MODIFICATION REQUESTS:

Thomas Street Car Park site, Chatswood

MP 09_0066 MOD 13 and MOD 14

Secretary's
Environmental Assessment Report
Section 75W of the
Environmental Planning and Assessment Act 1979
January 2015

Figure 2: Approved apartment layout (left) and proposed apartment layout (right)

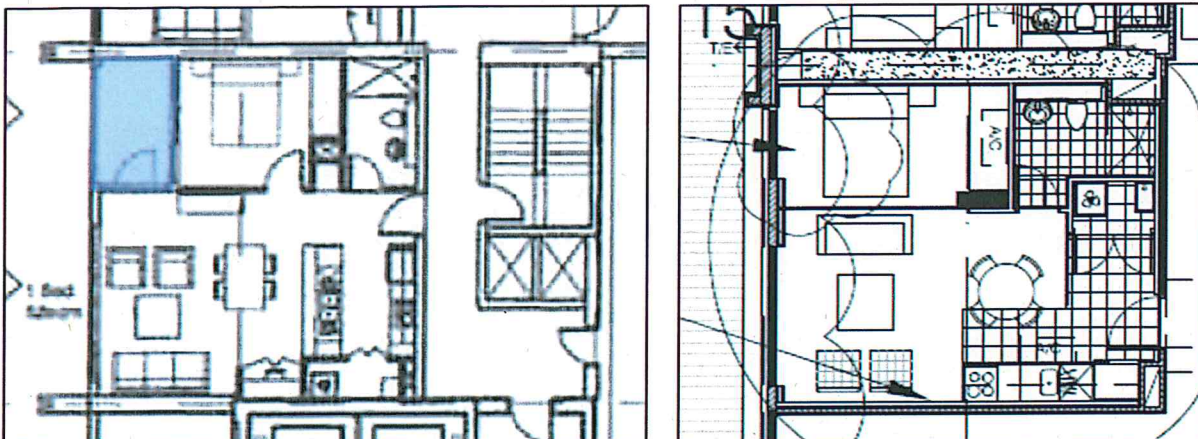
However, the Department notes that the proposal seeks to delete the balcony from three 1 bedroom apartments on the western side of Levels 1, 2 and 3 located in Building 1 (**Figure 2**).

The proposed deletion of the balconies (approximately 6m² each) for these apartments is offset by the increase in internal living space and internal storage. The Department also notes that the internal layout of the unit has been redesigned to provide a studio layout, with the bedroom partitioned from the living area, rather than a formally planned 1 bedroom apartment as originally approved.

The proposed apartments have a maximum depth of 7 metres which ensures that the whole apartment achieves a good level of daylight and natural ventilation. Further, the apartment has access to communal facilities including the residential pool, gymnasium and open space areas provided on Level 4. On this basis, the Department concludes that the revised apartment layout achieves acceptable amenity, despite not being provided with a balcony.

Figure 3: Aerial view of proposed roof over approved bridges between each building at level 4

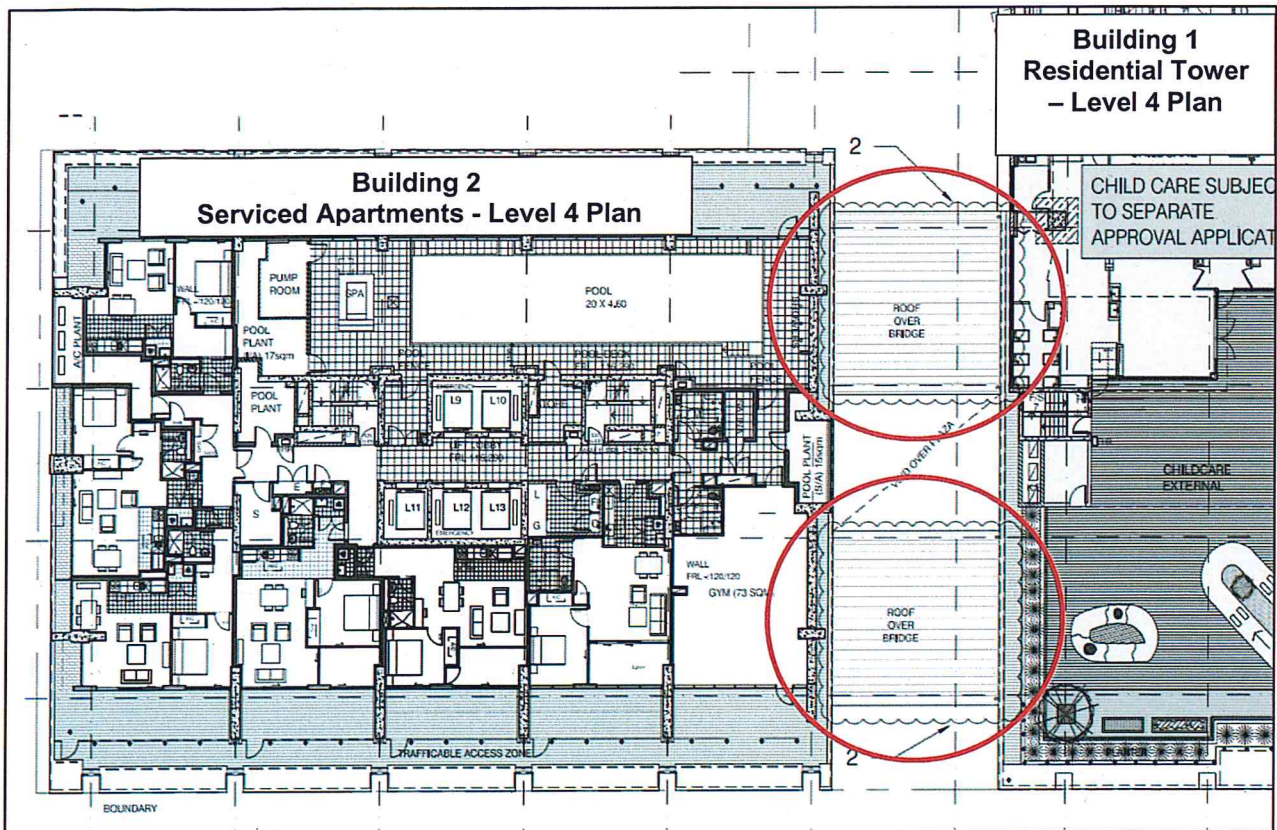
The proposal seeks to amend the bridges to erect two roof structures at level 4 as illustrated in **Figure 3** and provide glazed walls to enclose the bridges at levels 1, 2 and 3 (see section plan **Figure 4**).

Council does not object to this modification subject to the incorporation of artistic etching into the glazed wall of the bridges facing the public domain.

The proponent submitted amended plans including a notation that the glazing will be a clear or translucent glass with an etching pattern or other treatment that contributes to the artwork in the public domain.

With the incorporation of etching into the glazed panels, the proposed changes result in a high quality finish to the connection bridges and will provide weather protection for residents and guests. The Department recommends that an additional condition be imposed to require the details of the etching pattern or motif to be glazed panels visible from Thomas Street and Albert Lane Plaza to be approved by Council prior to issue of a Construction Certificate (CC) for the pedestrian bridges.
